From: Maria T Rodriguez
To: Reis, Juliana; Maurice R Hogg
Subject: RE: CEMEX Miami Cement Plant & SCL Quarry (EPAID FLD981758485) - Exit Interview
Date: Tuesday, December 22, 2020 5:33:39 PM
Attachments: image002.png
image001.png
Cemex Miami 30K Used Oil AST TCAR.pdf
Wash pit-1.2.PNG

This email serves as an exit interview for the Compliance Evaluation Inspection (CEI) conducted on Thursday, December 17, 2020, by the Florida Department of Environmental Protection (FDEP) to determine this facility compliance with the hazardous waste Federal and state regulations.

7. Universal Waste Lamps

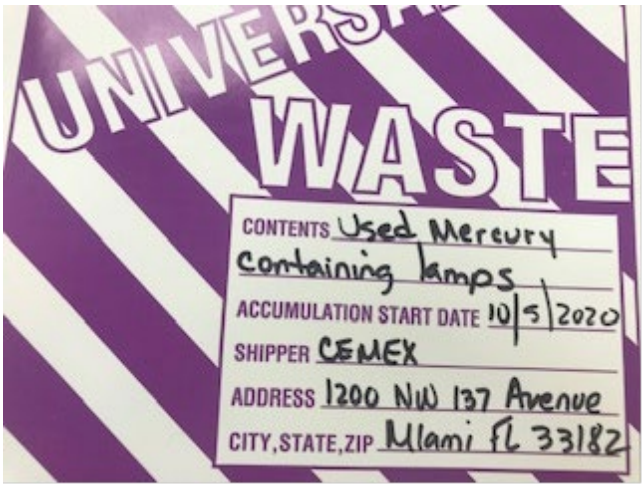
7. **Universal waste lamps – 40 CFR 273.13(d)**
   a. Provide pictures of the spent mercury lamps containers (attached picture) properly closed and sealed in order to prevent breakage.

Spent mercury lamps shall be specifically labeled as “universal waste-mercury-containing lamps”, “waste mercury-containing lamps” or “used mercury-containing lamps”.
   b. Provide a corrective action picture of spent mercury lamp’s containers properly labeled.

The photos below taken 12-22-20 , demonstrate that item **7 Universal waste lamps – 40 CFR 273.13(d)** of the CEI has been resolved. The spent mercury containers have been properly closed and sealed to prevent breakage, and labeled as specified.
